Project	IEEE 802.16 Broadband Wireless Access Working Group < http://ieee802.org/16 >	
Title	Harmonized H-ARQ MAP IE Corrections	
Date Submitted	2005-03-17	
Source(s)	<p>Yeongmoon Son, Changhoi Koo, Jungje Son, Steve Lee, Jonghyun Won, Geunhwi Lim, Wonil Roh, Jiho Jang</p> <p>Samsung Electronics Co. Ltd.</p> <p>Erik Lindskog, Kamlesh Rath, Dave Garrett and Brett Schein.</p> <p>Beceem Communications, Inc.</p> <p>Wen Tong, Mo-Han Fong</p> <p>Nortel Networks</p> <p>Yigal Eliaspur, Jose Puthenkulam, Randall Schwartz</p> <p>Intel</p> <p>Bin-Chul Ihm, Jin Young Chun</p> <p>LGE</p> <p>Mark Cudak, Kevin Baum</p> <p>Motorola</p> <p>Sean Cai, Jason Hou</p> <p>ZTE</p>	<p>Voice: +82-31-279-5845 FAX: : +82-31-279-5130 ym1004.son@samsung.com</p>
Re:	IEEE P802.16e/D6	
Abstract	Harmonized H-ARQ MAP IE Corrections	
Purpose	Adoption of proposed changes into P802.16e /D6	
Notice	This document has been prepared to assist IEEE 802.16. It is offered as a basis for discussion and is not binding on the contributing individual(s) or organization(s). The material in this document is subject to change in form and content after further study. The contributor(s) reserve(s) the right to add, amend or withdraw m

Figure B Reduced CID Decoding

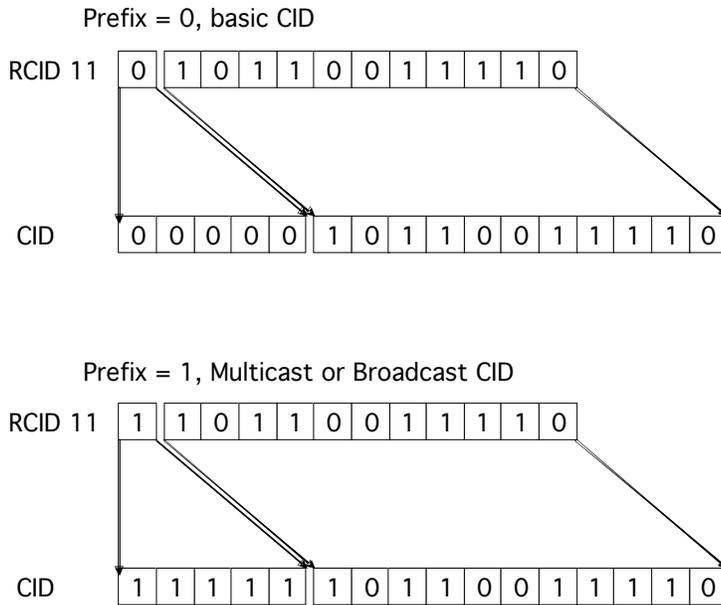
[Add the following text in the section 8.4.5.3.21.2 Reduced CID IE]

Table A presents the format of reduced CID. BS may use reduced CID instead of basic CID or multicast CID to reduce the size of H-ARQ MAP message. The type of reduced CID is determined by BS considering the range of basic CIDs of SS connected with the BS and specified by the RCID_Type field of the Format Configuration IE. The reduced CID is composed of 1 bit of prefix and n-bits of LSB of CID of SS. The prefix is set to 1 for the broadcast CID or multicast CID and set to 0 for basic CID. The reduced CID can not be used instead of transport CID, primary management CID or secondary management CID.

Figure B shows the decoding of reduced CID when the RCID_Type is set to 3.
